Your Ref
EG/63/18/HH
Our Ref
PLAN-024724
Date
17/10/2018

Proposal: 2no. front extensions, new roof to include accommodation at first floor level & internal alterations throughout.
Site: 40 Elm Grove, Barnham, PO22 0HL.
EG/63/18/HH

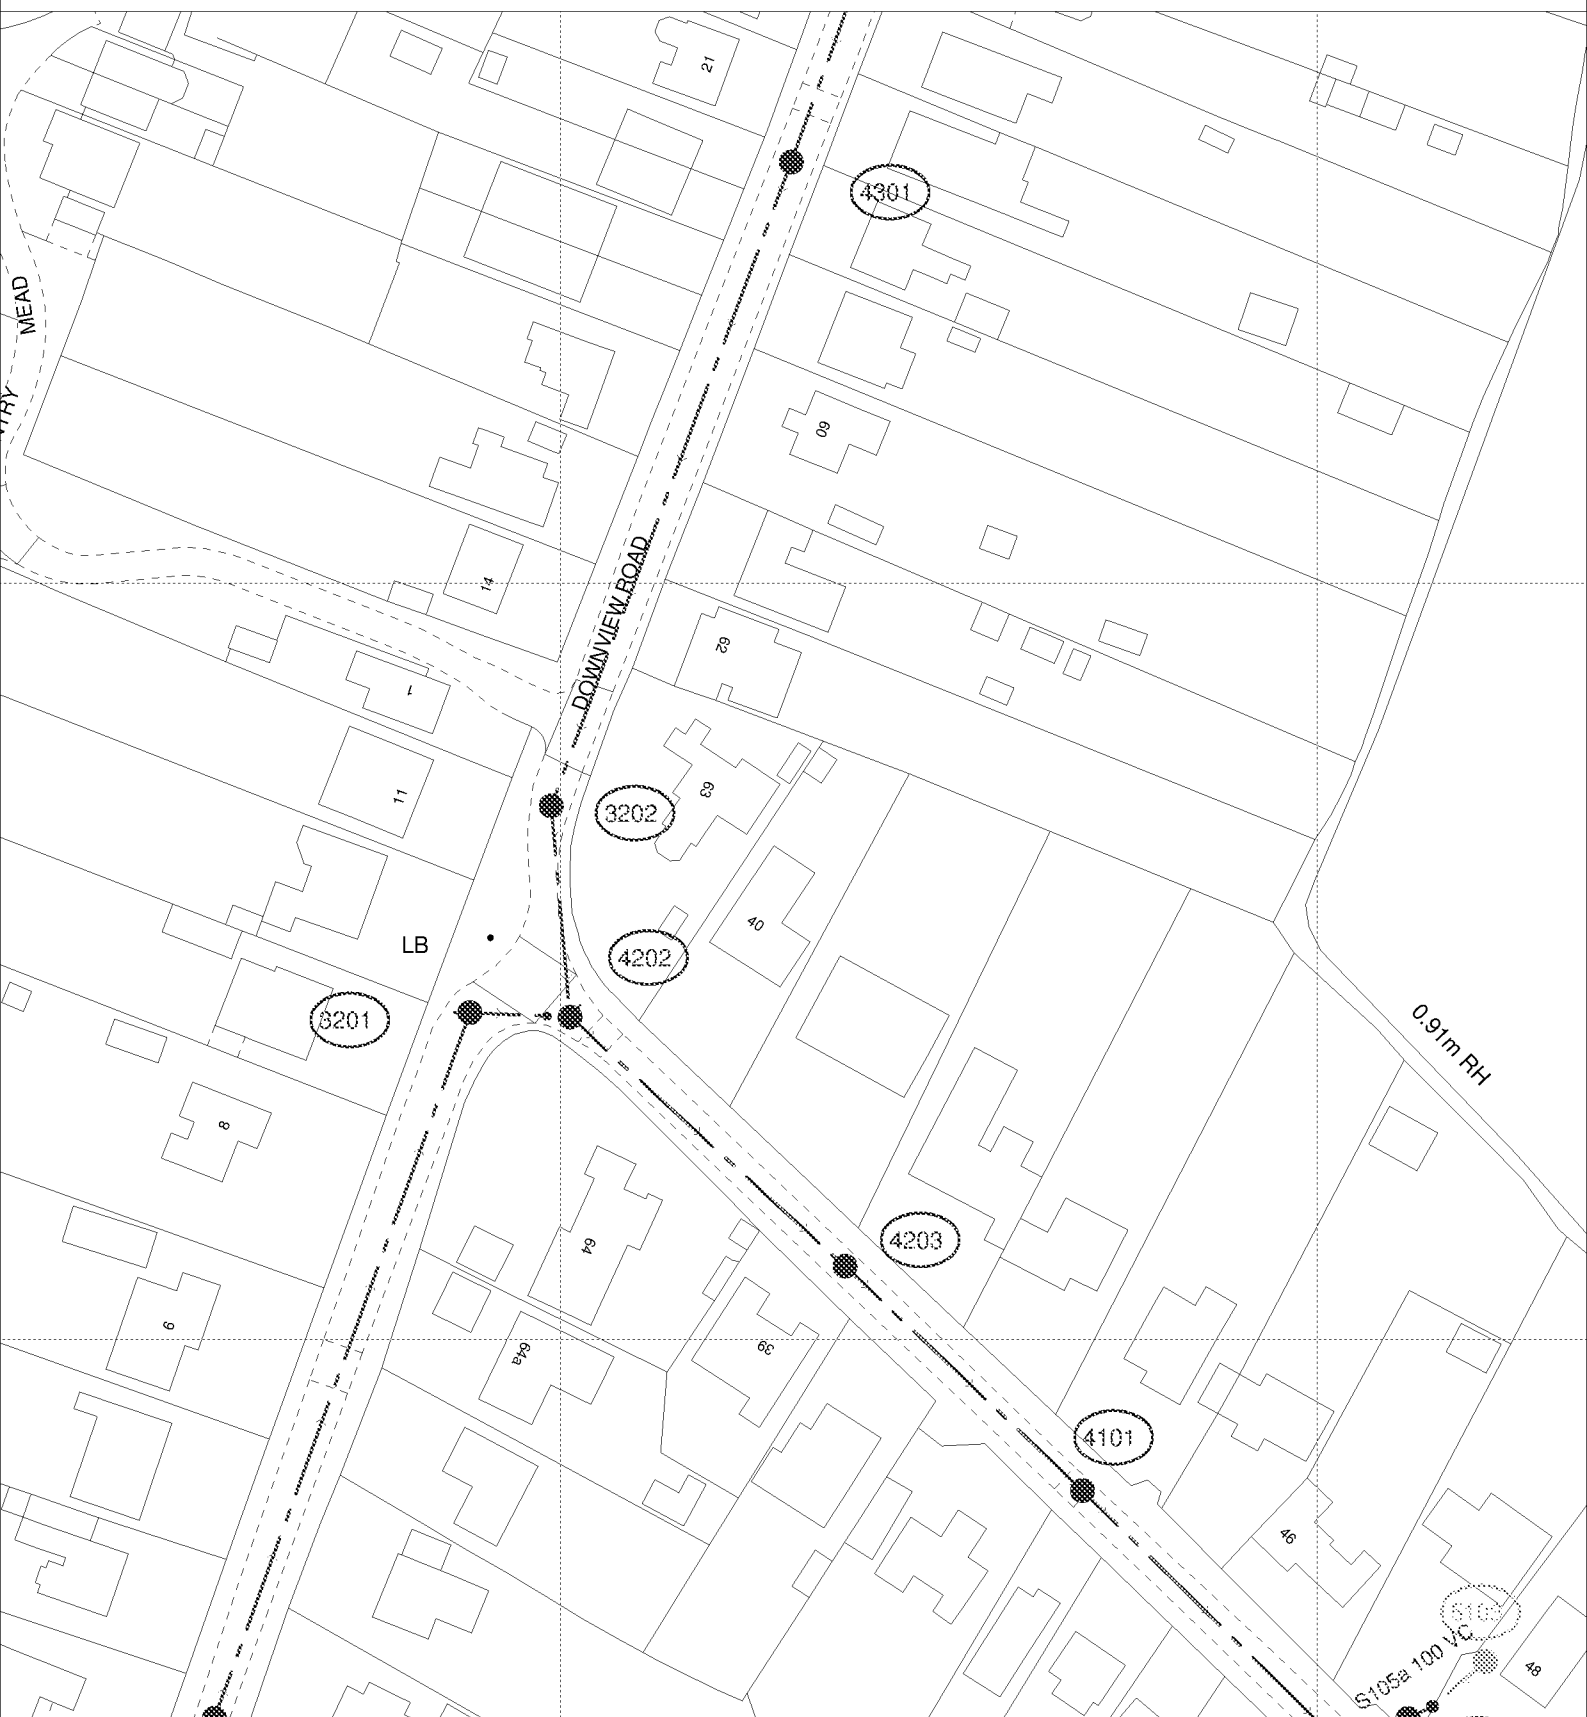
Due to surface water inundation issues in the Lidsey Catchment "The applicant is advised to adopt, where appropriate, the measures in the table "Practical measures to reduce the potential impacts of development".

Developer should look to protect the public sewerage system from inundation and infiltration, which contribute to flooding in unfavourable conditions.
